ADDENDUM #1 -- CPS RFP 20/69 --

BENTON ELEMENTARY MOBILE CLASSROOMS SITEWORK PACKAGE

DATE: AUGUST 21, 2020

Benton Elementary Mobile Classroom Sitework Package

DESIGNED: JRS
DRAWN: JAA
PROJECT NO.: 180231
SHEET: CE 4

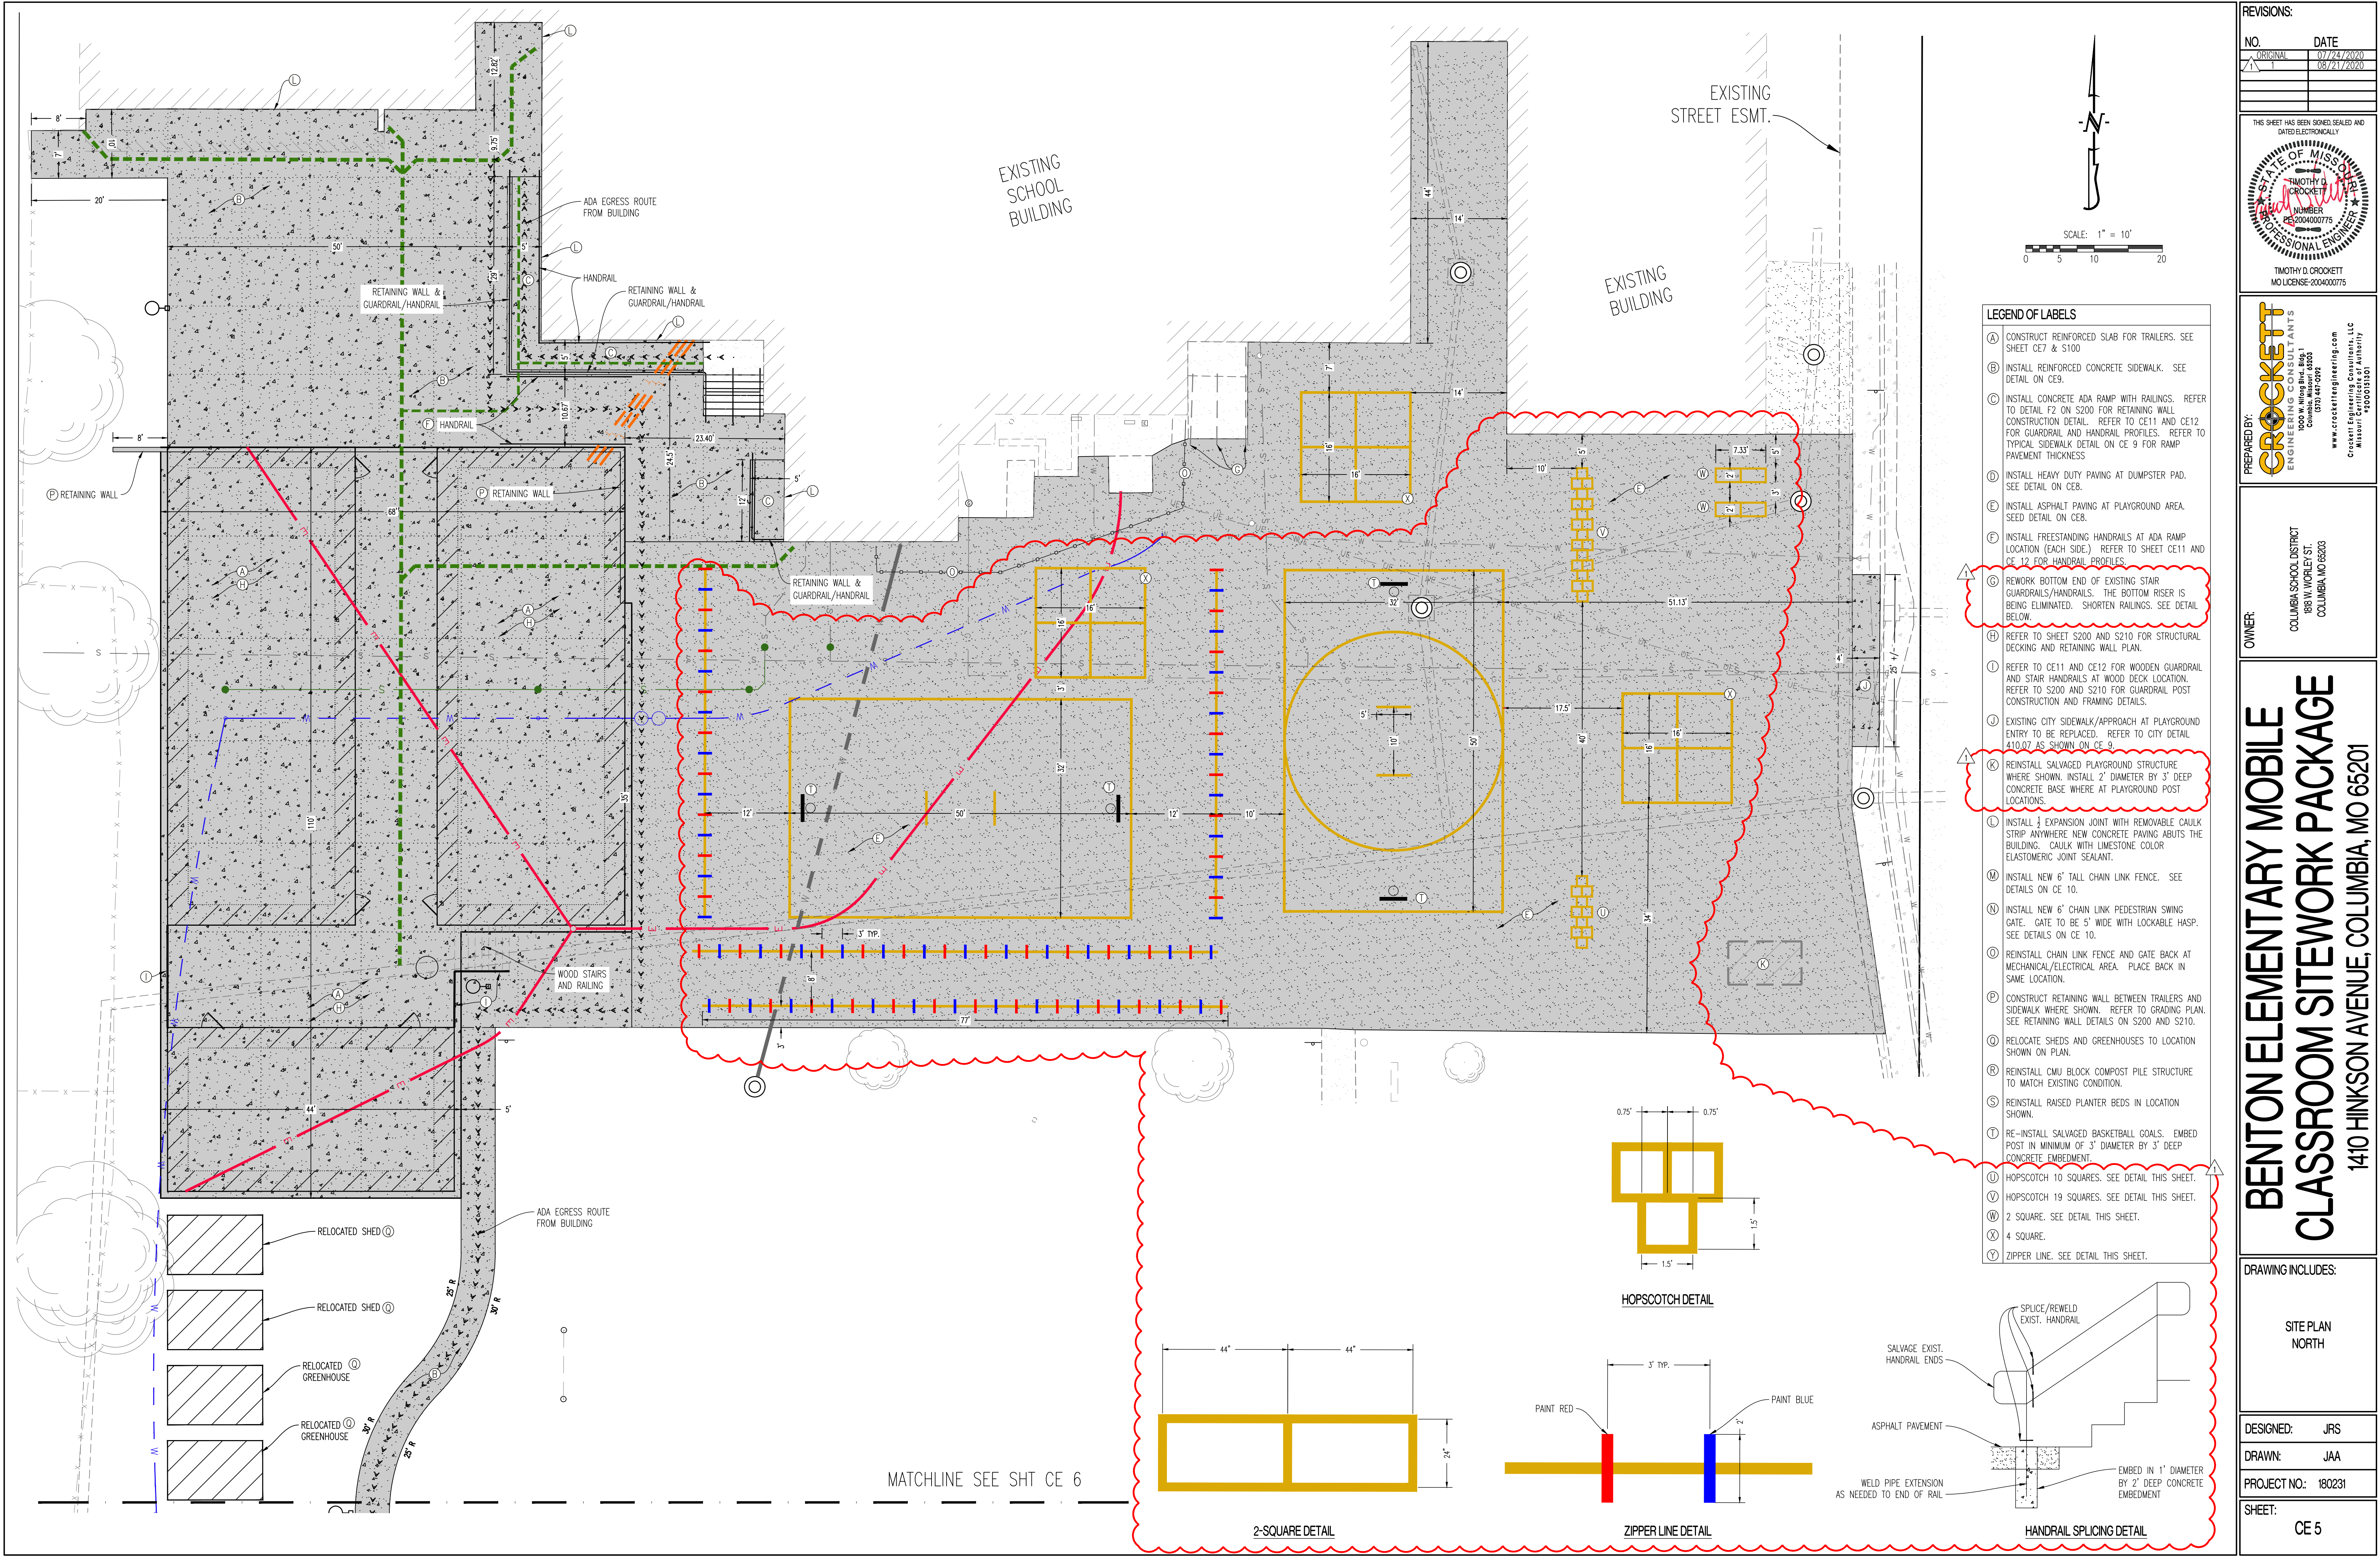
1. Does the \$20,000 Allowance-B for sewer repairs shown on the Unit Price and Allowance form cover key note items F, J, & K as shown on CE4?
 - a. *The \$20,000 sewer allowance would not cover key note "F" because the tap location is known. The \$20,000 sewer allowance would also not cover the capping of the existing tap shown in key note "J" because the location and depth of this work is known. The \$20,000 sewer allowance would also not cover the installation of the two new cleanouts shown in key note "K" since those location and depths are known. The \$20,000 sewer allowance would cover any investigative camera work needed to determine if there is additional problems between the main and the building for each of the sewer laterals affected. It would also cover any remediation work needed to replace those laterals as needed.*

2. Is there any elevation information on the existing RCB where roof drain "H" ties into the line?
 - a. *Exact depths are unknown, but based on available information, we believe the flow line of the RCB is no deeper than 6' below existing grade.*

4. Sheet CE4
 - a. Underground electric conduit routing modified to match the existing trailer that is to be re-installed.
 - b. Note "D" clarified that water meter shall be 1".

- c. Note "G" modified to show detail of data conduits at building entry location.
 - d. Note "O" added to account for riser adjustment needed at buried storm manhole access location.

- (O) BURIED STORM LID ACCESS. CONTRACTOR SHALL UNCOVER EXISTING MANHOLE GRATE AND PROVIDE A PRECAST RISER EXTENSION AS NEEDED TO EXTEND THE GRATE TO PROPOSED FINISH GRADE. AN ACCESS PORT DIRECTLY OVER TOP OF THE LID SHALL BE GRADED IN THE DECKING. SEE DETAIL S200A SHOWN ON ADDENDUM #1.

SHEET: CE 5

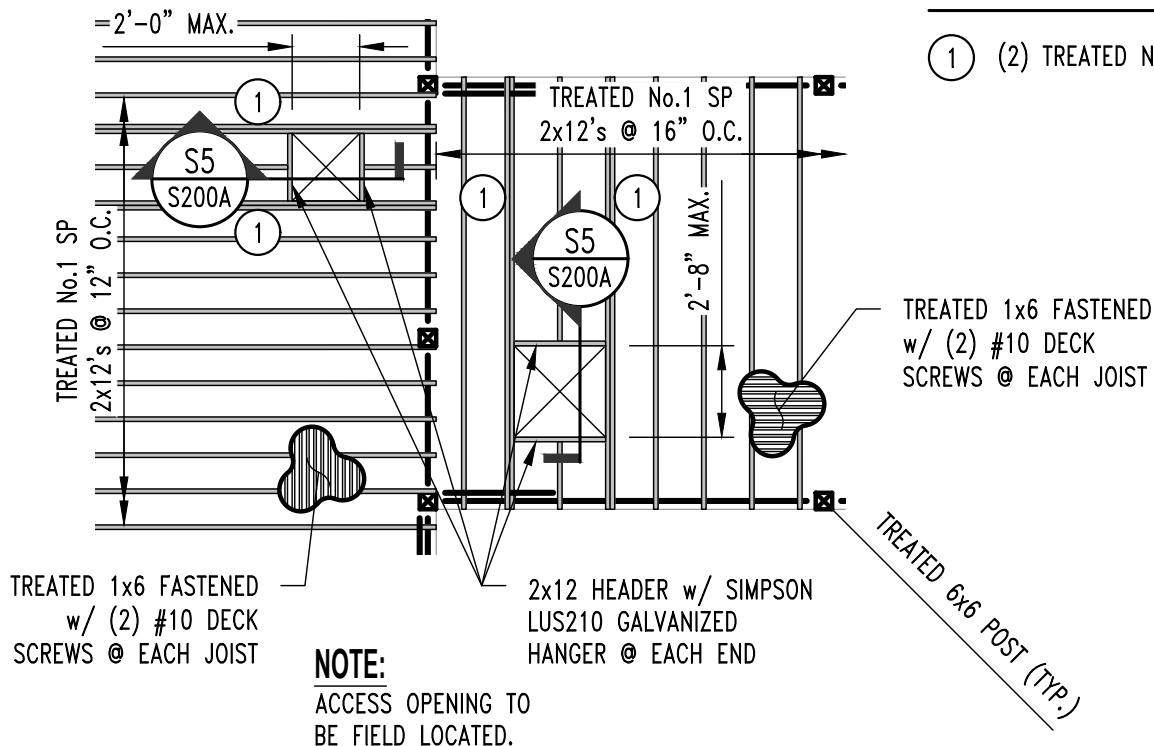
5. Sheet CE5
 - a. Playground striping and overall configuration has been modified. See key notes "U,V,W,X,Y"
 - b. Additional detail added for Note "G" showing handrail modification.

- c. Note "K" modified to show concrete requirements at post embedment of playground structure.

S200A

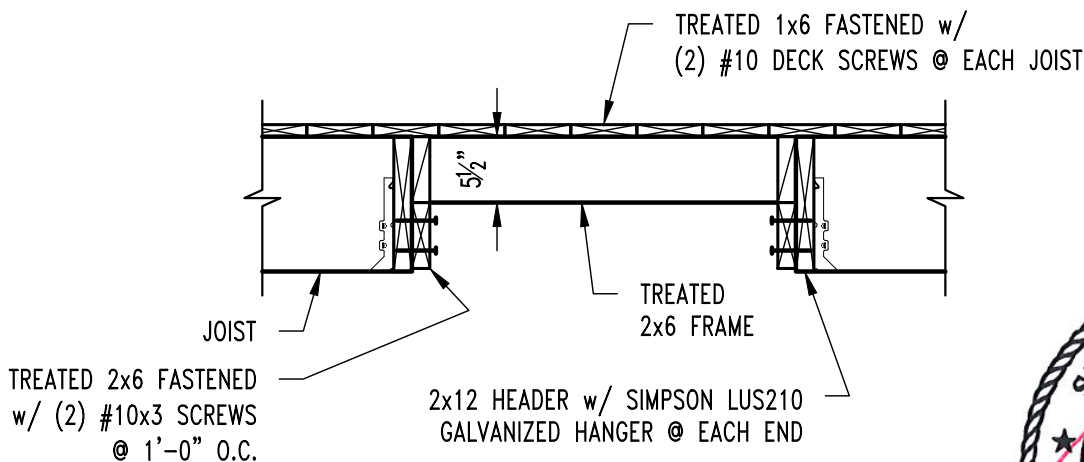
6. Sheet S200A
 - a. A typical detail has been added to allow for an access hatch in the wood deck framing. The exact location will be determined once a buried storm manhole is uncovered.
7. Sheet E101
 - a. The riser diagram has been modified to eliminate the meter can.

POWER RISER

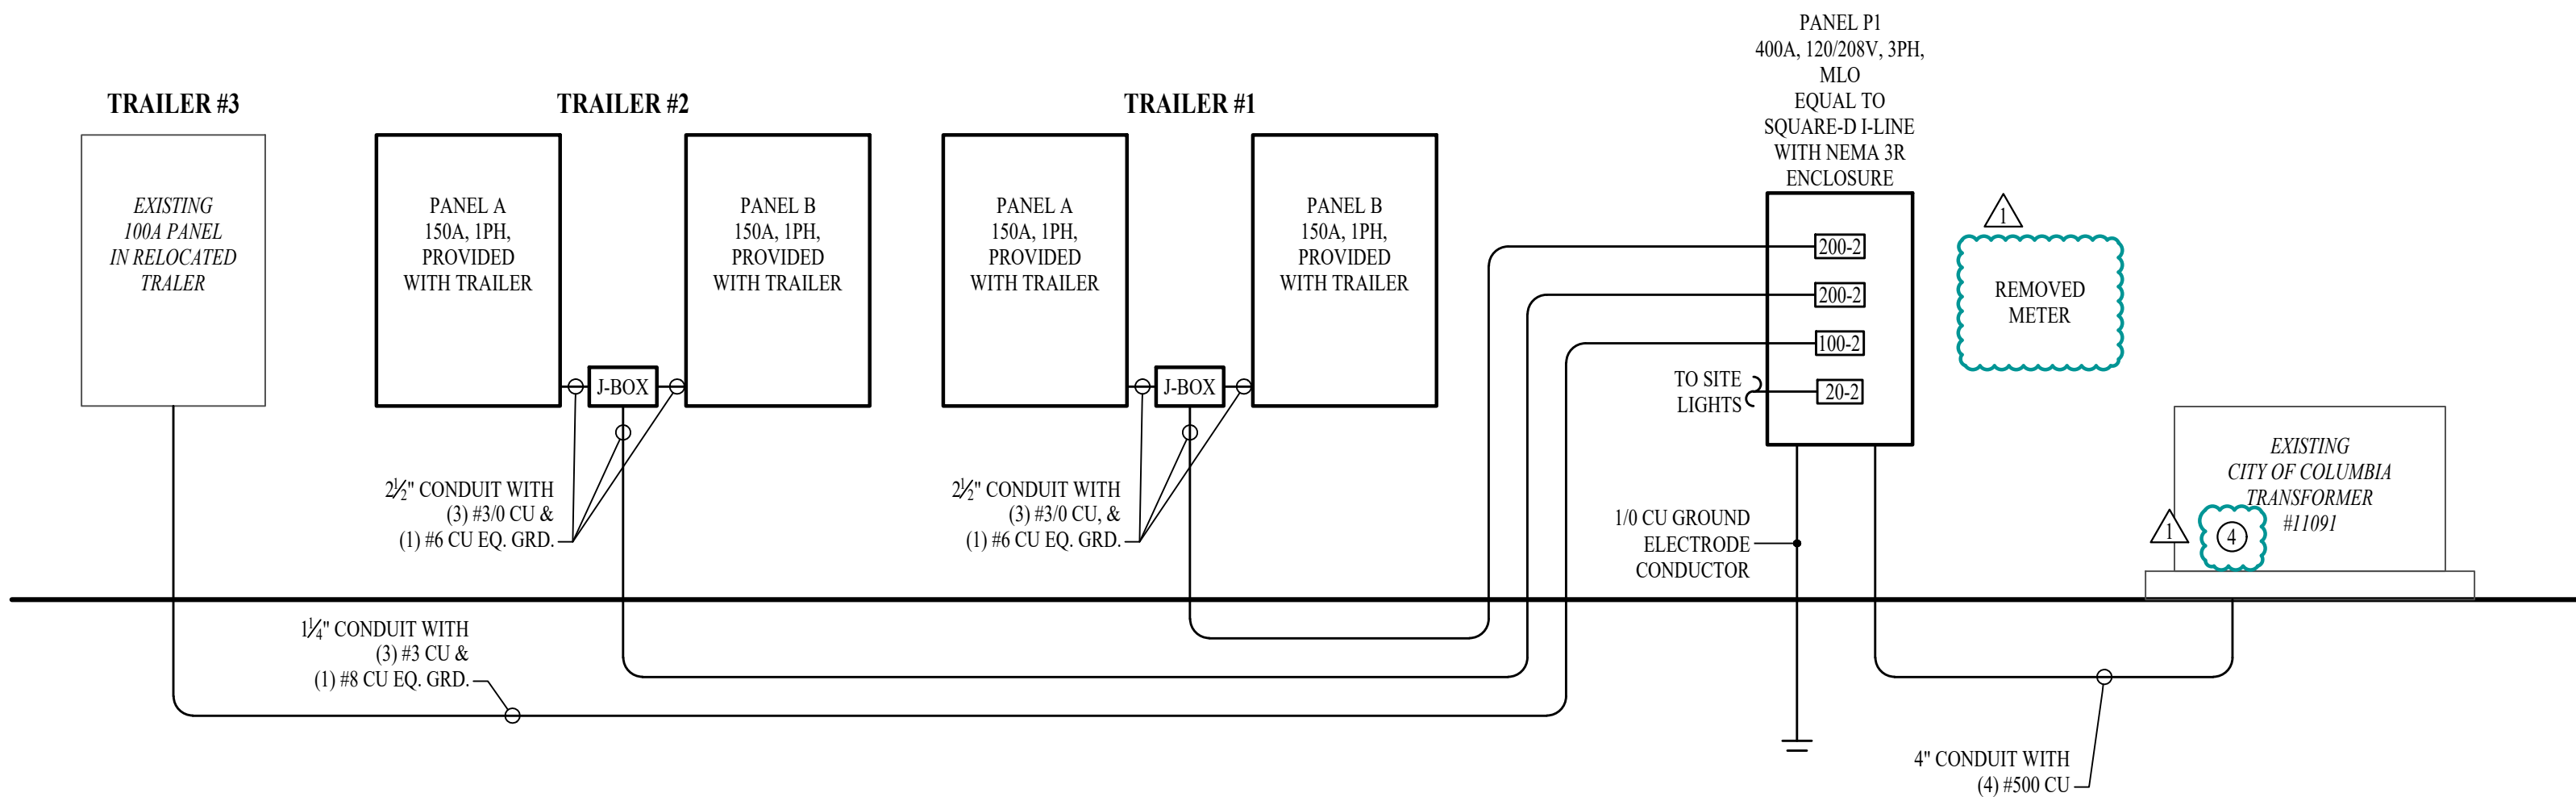
3. Is there a box framed opening in the transformer big enough for the 4" conduit to enter under the transformer?
 - a. *Yes. See the attached picture from City Light department showing the condition of this transformer. They also determined that that all metering is done by the CT's that are already on the transformer bushings. This means the new conduit can come up on the same side as those bushings and a new metering can is no longer required. See the attached revision to the electrical plans showing this.*
